# Access Compliance Report

### (Curb Ramps)

Intersection ID: 54709	Main Street: MARY_BUTLER_WY	Cross Street: OLD_PROVIDENCE_RD	Location: SE
ADA ID: F3D7D63657DD	Ramp Type: Perp	Initial Pass/Fail: Fail	Overall Compliance: No
Severity Score: 12.5			
Codes/Mitigation Info/Possible Solution		Field Measurements/Component Compliance

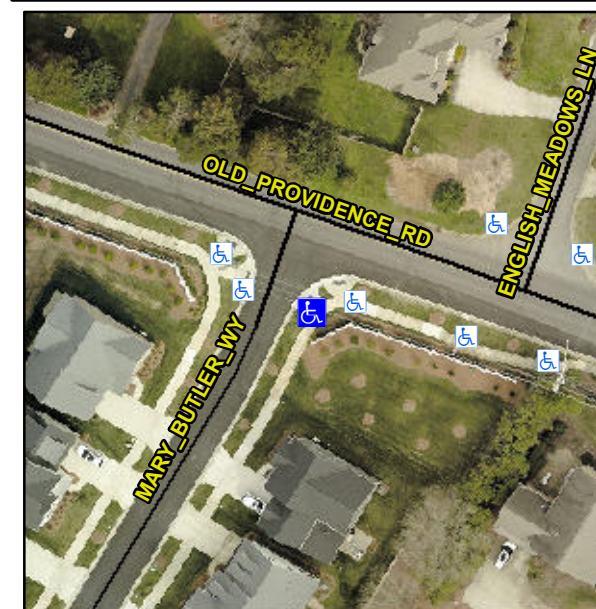
**R304.5.3**

**Remove & Replace Entire Ramp.**
